Re: Criteria Revision – Public

Public Comments
of
Pilkington North America, Inc.
to the
U.S. Department of Energy's
Energy Star Program's
Draft Report of Criteria and Analysis for Windows, Doors, and Skylights

APPENDIX A
Showing Average Annual Home Energy Consumption ES 3
Using 0.35 and 0.30 U-factor and SHGC from 0.00 to 0.70

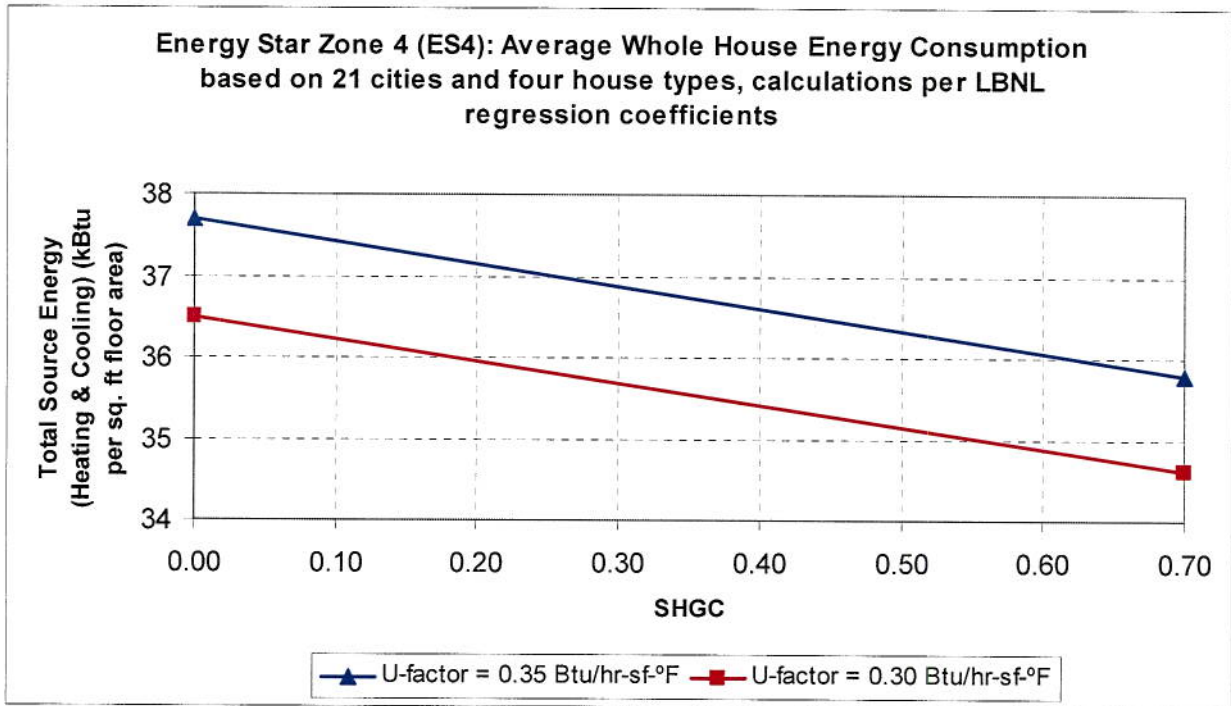
Appendices A, B and C attached hereto, graph the average energy consumption of homes in ES 3, 4 and 5, respectively. These graphs use the same cities and the same regression coefficients used to develop the current Energy Star Report. Each graph plots energy consumption against windows having 0.30 and 0.35 U-factors, respectively, and against windows having SHGCs ranging from 0.00 to 0.70. As can be seen on each of the three (3) attached graphs, **as SHGC increases in ES 3, 4 and 5, total annual energy consumption decreases.** The further north you go, from ES 3 to ES 5, the larger, or steeper, the decrease in total average energy consumption.

The Energy Star Report acknowledges that there is no energy efficiency basis upon which to impose a 0.40 SHGC cap in ES 3. “IECC 2009 has no SHGC criterion for this region, because the energy savings analysis shows that solar control provides only modest benefits in this climate zone.” Energy Star Report, p. 18. No other justification for reducing the SHGC cap from 0.55 to 0.40 in this zone is articulated in the Energy Star Report. Perhaps, most surprising is that Appendix A attached hereto, which was prepared using the same regression coefficients upon which the Energy Star Report is based, actually establishes that a window with a 0.30 U-factor (which satisfies part of the new criteria), with an SHGC of 0.55, (which will disqualify it under the proposed criteria) actually saves more energy than the same window with an SHGC of 0.40 that meets the new criteria.

APPENDIX B
Showing Average Annual Home Energy Consumption ES 4
Using 0.35 and 0.30 U-factor and SHGC from 0.00 to 0.70

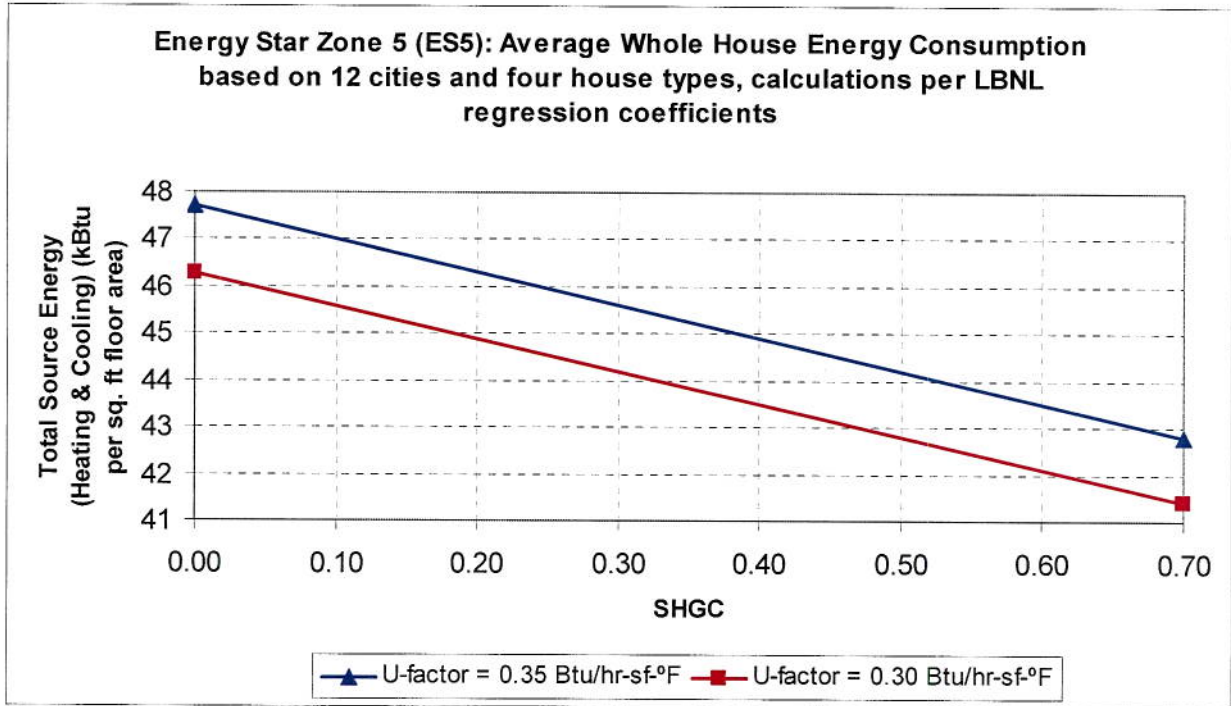
Nowhere in the Energy Star Report is there reference to any objective evidence of any kind to support DOE's proposed inclusion of a 0.55 SHGC cap in ES 4 or 5 in Phase 1 or Phase 2. In fact, the objective evidence is to the contrary. **SHGC levels above the proposed 0.55 cap will save more energy than SHGC levels below the proposed 0.55 cap in ES 4, and will save even more energy in ES 5.** See, Appendices B and C attached hereto.

4. The Energy Star program is "designed to help reduce national energy consumption by increasing the energy efficiency of fenestration products in residential buildings." Energy Star Report, p. 4. As demonstrated in Appendices B and C, eliminating the 0.55 SHGC cap in ES 4 and 5 will achieve the objective of reducing national energy consumption.

There is no legitimate basis for the imposition of a 0.55 SHGC cap and it will arbitrarily disqualify energy efficient products from qualifying for an Energy Star label. The 0.55 SHGC cap should be eliminated from the Phase 1 and 2 criteria for ES 4 and 5.
